A PROPOSED TOWNHOME COMMUNITY BY:
THE BOULEVARD COMPANY

HILLSIDE EAST

PETITION NO.: 96-35

DATE: December 4, 1997
 FROM: *mcc* (cc) Martin R. Cranton, Jr. Planning Director
 TO: Robert Brandon Zoning Administrator
 SUBJECT: Administrative Approval for Petition No.96-35, Hillside East. The Boulevard Company. Tax Parcel No. 151-092-30.

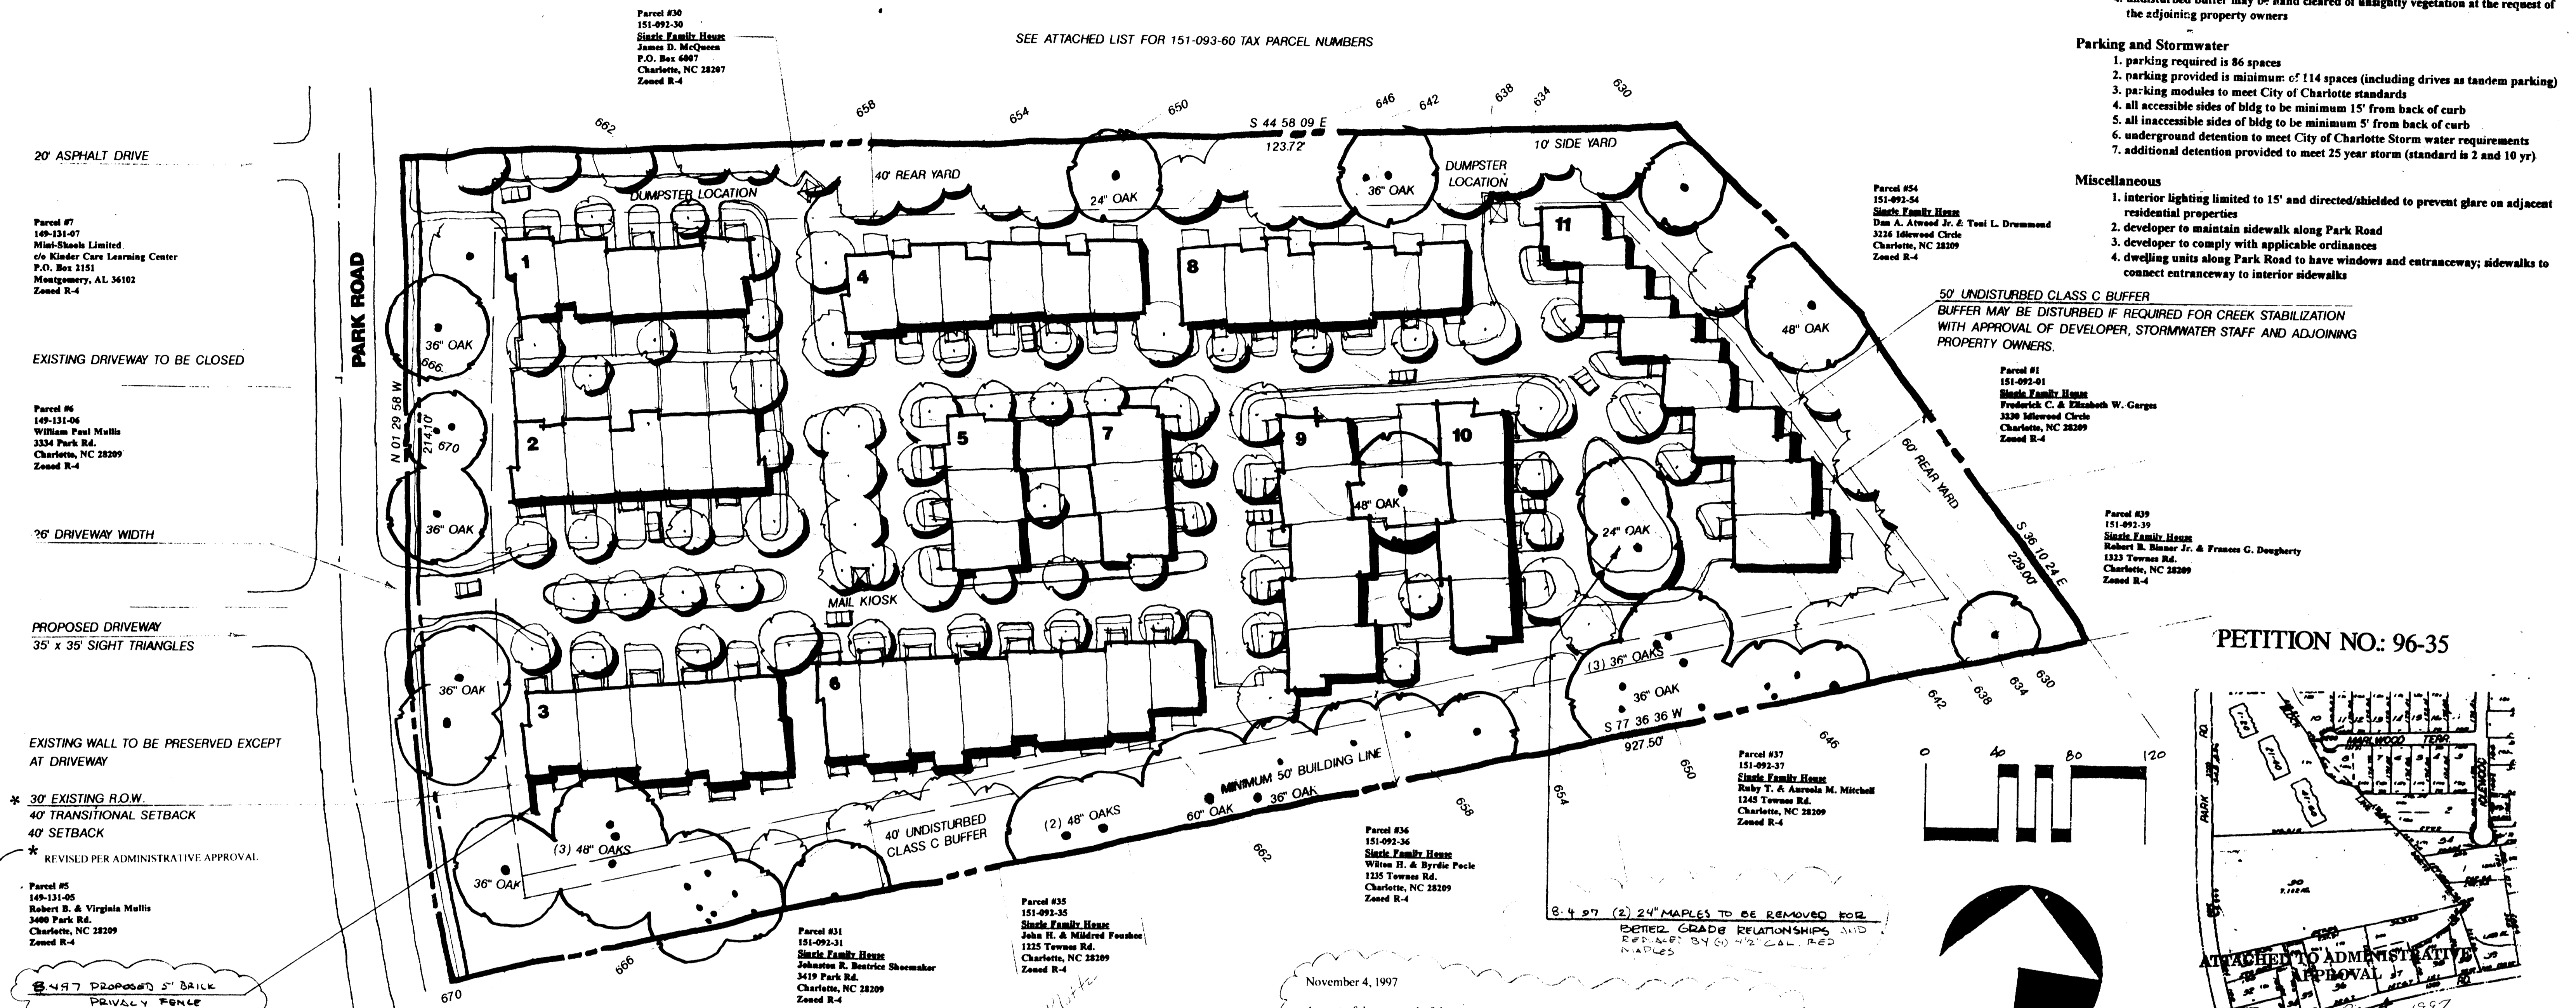
* REVISED PER ADMINISTRATIVE APPROVAL
 SEE NOTE BOTTOM LEFT

* REVISED PER ADMINISTRATIVE APPROVAL

October 23, 1997
 Additional right-of-way to be dedicated 10' from back of curb before issuance of building permits. The owner(s) of the property will dedicate right-of-way shown on the plans (shown as reserved) to the Charlotte Department of Transportation up to a maximum of 40' from the centerline of Park Road in conformance with the conditional development notes. This note to also appear on all recorded plat

November 4, 1997

As part of the approval of the stormwater system as shown on the subdivision plan, the developer commits to applying for the stormwater credit program through the City of Charlotte Engineering Department. See attached letter.

- 1.) The removal of 2 1/2 inch caliper maples in the cul de sac to the rear of the site. To create a better grade relationship these trees are to be removed and replaced with 4 1/2 inch caliper maples.

- 2.) The addition of a brick privacy wall to building #1 to give the property owner privacy in their rear yard.
- 3.) The revision of the requirement of dedication of 40 feet of right of way prior to the issuance of any building permits with reservation and dedication of up to 40 feet from centerline upon request by the City of Charlotte Department of Transportation. This revision is required to accommodate the location of a brick retaining wall out of the public right of way and to further protect existing trees to be saved in the setback.

- 4.) The acceptance of the storm water system as shown on the approved subdivision plans with the commitment by the developer to apply for storm water credits thereby committing to annual inspection and required maintenance as determined by the City of Charlotte engineering staff.
